POWER PLANT - ENGINE - INCORPORATE REVISED CLIPPING REQUIREMENTS AT CP1001 - CATEGORY
CODE 5 - MOD.ENG-71-0053

V2500-ENG-71-0053

**SERVICE BULLETIN**

EEC Fan Harness Clipping Detail at CP1001 - Before and After Alteration
Fig.1 (Sheet 1)

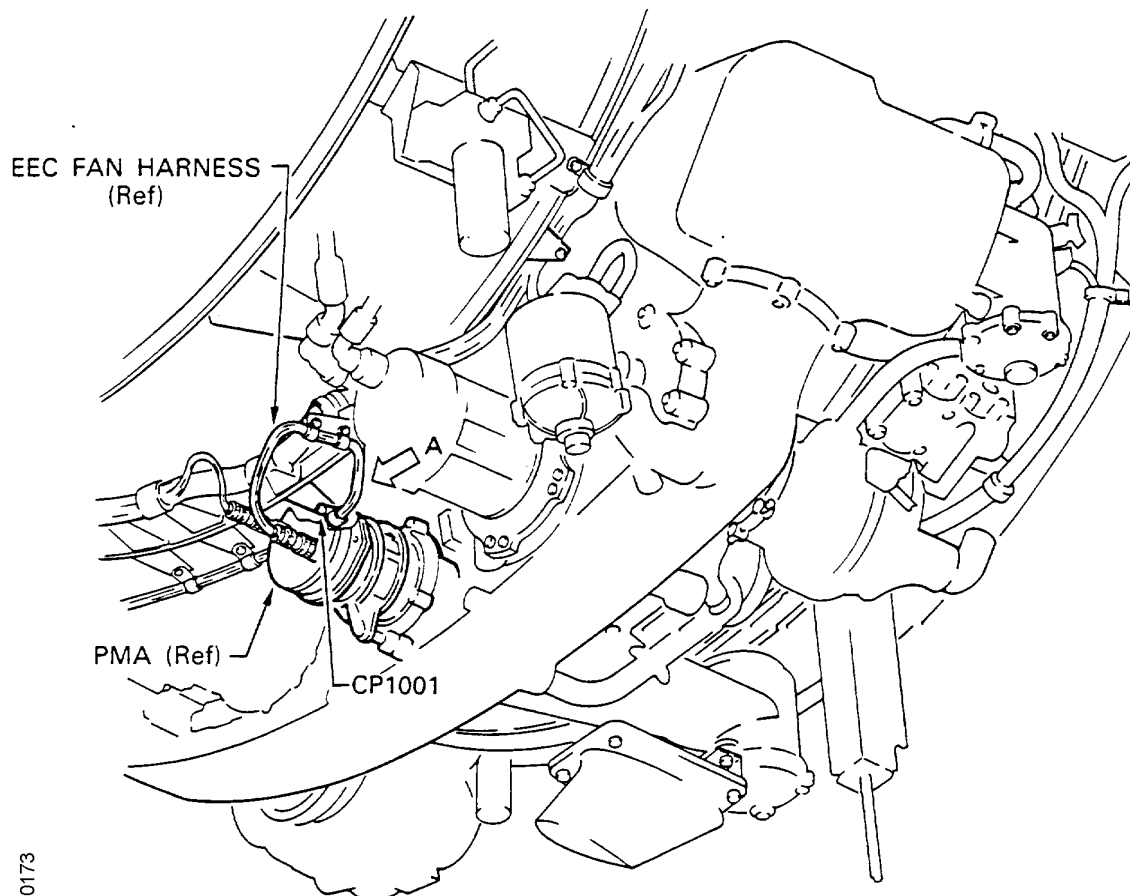
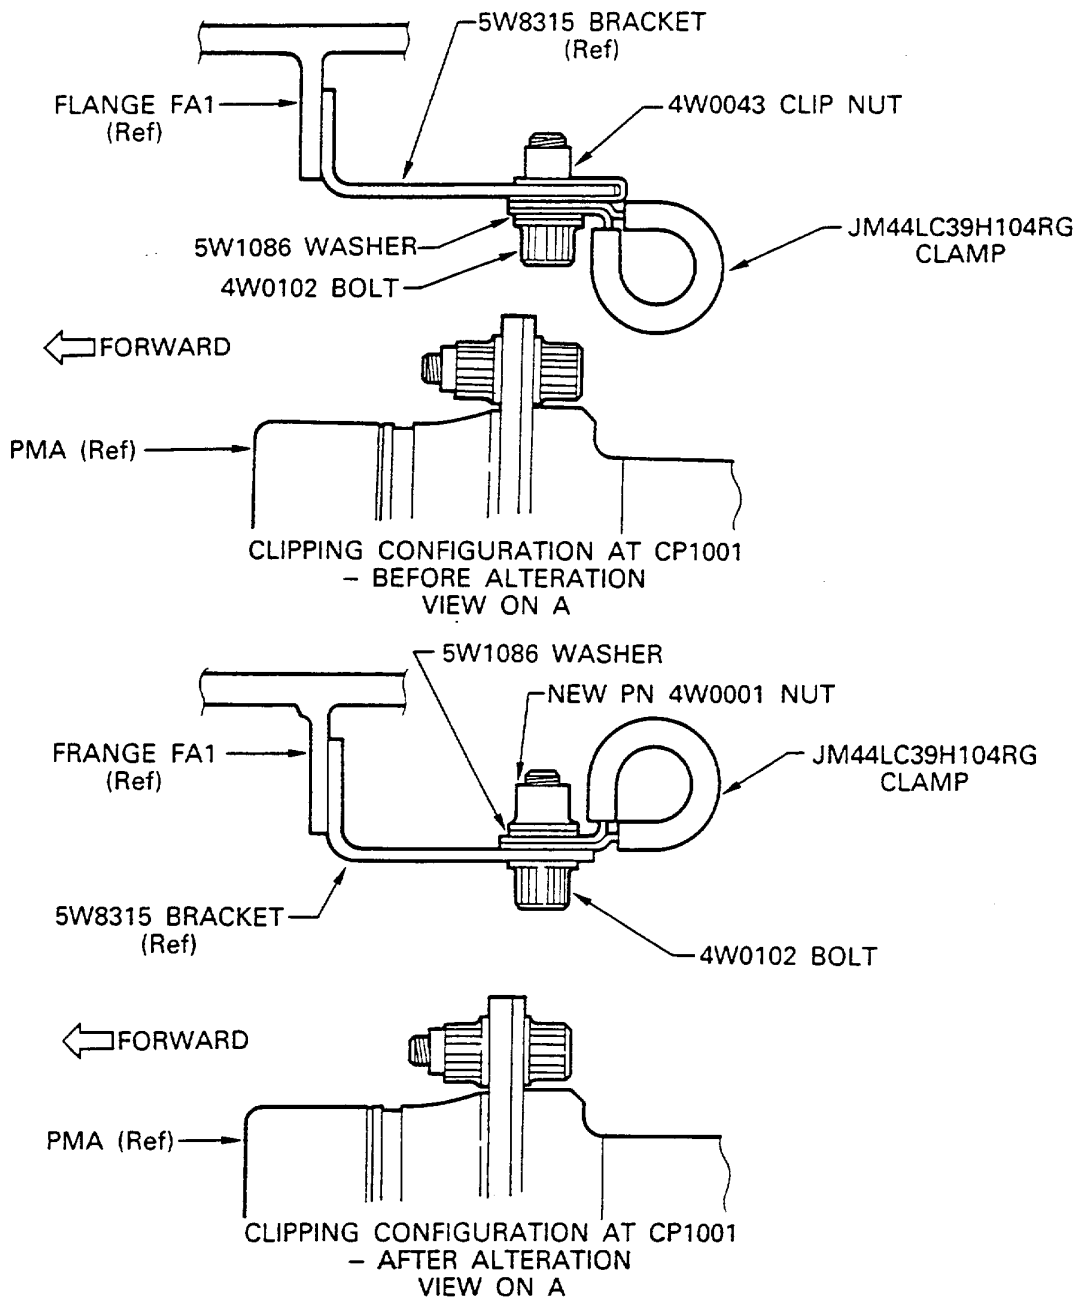
- (a) At clipping position CP1001, the existing Clamp is turned upside down to reroute the EEC Fan Harness. (See Figure 1).
- (b) At clipping position CP1001, the Nut is changed from the clip nut to the ordinary nut. (See Figure 1).

- (1) At CP1001, Install PN 4W0102, Bolt, PN JM44LC39H104RG, Clamp, PN 5W1086, Washer, and new PN 4W0001, Nut to the EEC Fan Harness and PN 5W8315, bracket, by the procedures given in the Engine Manual. (refer to Figure 1, and Engine Manual, 72-00-32, LP Compressor/Intermediate Case Module - Installation, TASK 72-00-32-420-004).
